M^CLAREN TRAFFIC ENGINEERING

Reference: 190226.16FC

LETTER OF RESPONSE TO RMS COMMENTS FOR PROPOSED LEISURE AND ENTERTAINMENT PRECINCT AT CNR PARK STREET & WARLTERS STREET, PORT MACQUARIE

FIGURE 1: PROPOSED RIGHT TURN ARRANGEMENTS

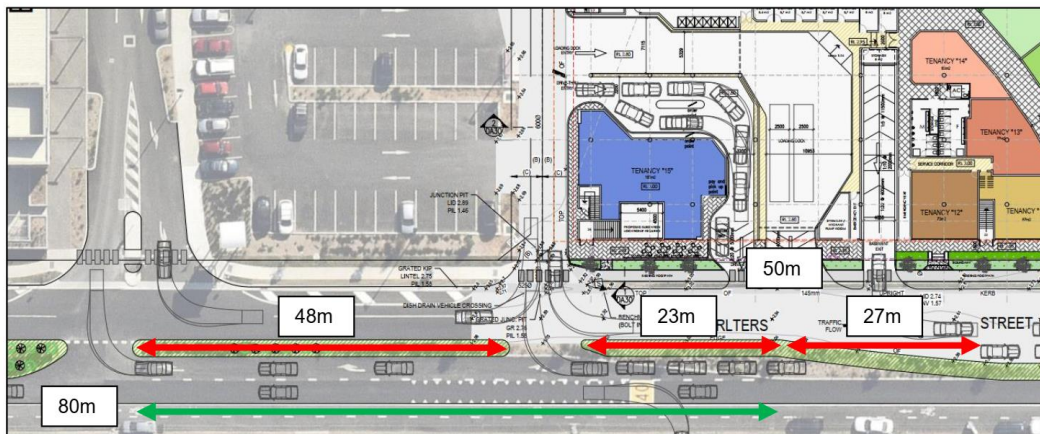
It is noted that an additional gap is to be provided in the median section of Warlters Street, to allow an additional right turn into and out of the site at the eastern side of the Kmart parking area. Warlters Street is a 2-lane road with provision of on-street parking in sections of the roadway. No Austroads assessment of the new right-turn facility has been provided; particularly, to assess the appropriate storage length of the right turn bay; or the impact of the new turn on the existing right-turn facility further to the west.

As a part of the DA for the Port Macquarie cinema complex, a new right turn bay into the site from Warlters Street has been proposed, as depicted in **Figure 1**. Mr Grant Burge from Port Macquarie Council has questioned the adequacy of the proposed right turn bay, as well as the existing right turn bay, which has been shortened as a result of the proposal.

The relevant Austroads Guide for auxiliary turning lanes for public road intersections is *Austroads Guide to Road Design Part 4A*. The proposed auxiliary lane provides access to private driveways rather than public roads; therefore it is the opinion of MTE that this Guide does not necessarily apply to these right turn auxiliary lanes. Nonetheless, the auxiliary right turn lanes are compliant with the Austroads Guide, as summarised in **Annexure E**.

Reference is made to *Section 5.2* and *Section 7.8* of *Austrroads Guide to Road Design (Part 4A)*, which provides road design guidelines for deceleration lanes. The relevant formulae and tables are reproduced in the Annexure to this report. It is noted that there is no mandatory requirement to provide an auxiliary lane at private driveways. In any case, MTE has assessed the existing and proposed auxiliary lanes purely for exercise purposes.

FIGURE 2: DIVERGE LENGTH FOR PROPOSED KMART DECELERATION LANE

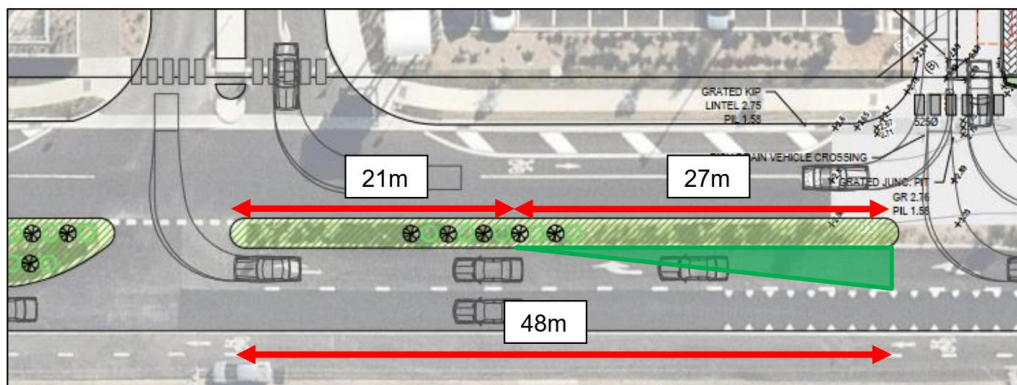
The diverge length in accordance with *Table 5.2* of the Austroads Guide for a 50 km/h design speed is 27m. This should be provided along the turn bay as shown in **Figure 2** to satisfy the Austroads Guide.

As shown, a vehicle can be traveling up to 52.2 km/h in order to have enough deceleration length to utilise the proposed 48m length deceleration lane into the existing Kmart access. The posted speed limit along Warlters Street is 50km/h outside school periods and 40 km/h during school periods. Therefore, the proposed 48m deceleration lane satisfies the Austroads Guide.

FIGURE 3: DIVERGE LENGTH FOR PROPOSED Kmart DECELERATION LANE

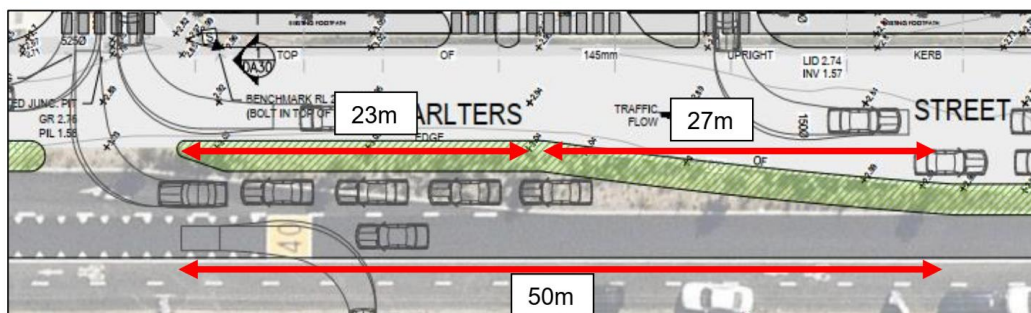
The diverge length in accordance with *Table 5.2* of the Austroads Guide for a 50 km/h design speed is 27m. This is consistent with what is proposed in the site plan (reproduced in **Figure 3**).

As shown, a vehicle can be traveling up to 52.7 km/h in order to have enough deceleration length to utilise the proposed 50m length deceleration lane into the existing Kmart access. The posted speed limit along Warlters Street is 50 km/h outside school periods and 40 km/h during school periods. Therefore, the proposed 50m deceleration lane satisfies the Austroads Guide.
